OREGON STATE UNIVERSITY

AMENDMENT TO AMENDED FACILITY OPERATING LICENSE

Amendment No. 16
License No. R-106

ENCLOSURE TO LICENSE AMENDMENT NO. 16

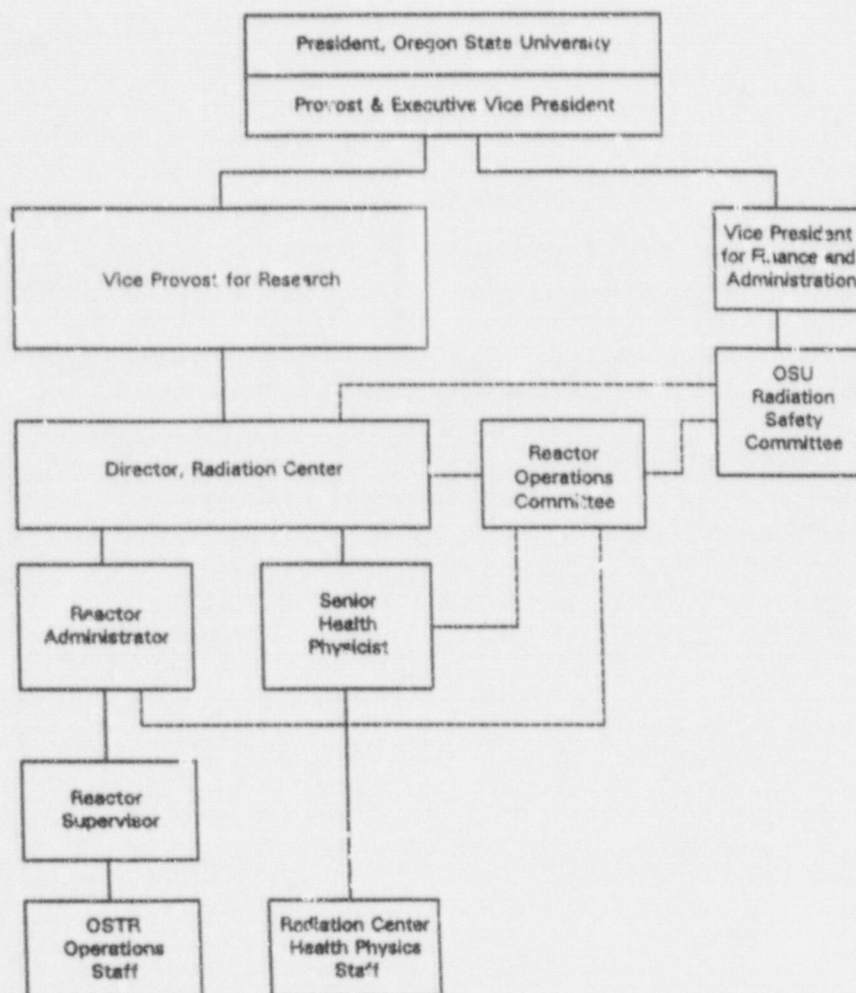
- a. The facility shall be under the direct control of the Radiation Center Director or a licensed senior operator designated by the Director to be in direct control. The Radiation Center Director shall be responsible to Oregon State University's Vice Provost for Research for the safe operation and maintenance of the reactor and its associated equipment. The Radiation Center Director, or an individual appointed by the Director, shall be responsible for assuring that all operations are conducted in a safe manner and within the limits prescribed by the facility license and the requirements of the Reactor Operations Committee. The Radiation Center Director shall enforce rules for the protection of personnel against radiation.
- b. The safe operation of the OSTR shall be related to the University Administration as shown in the following chart:
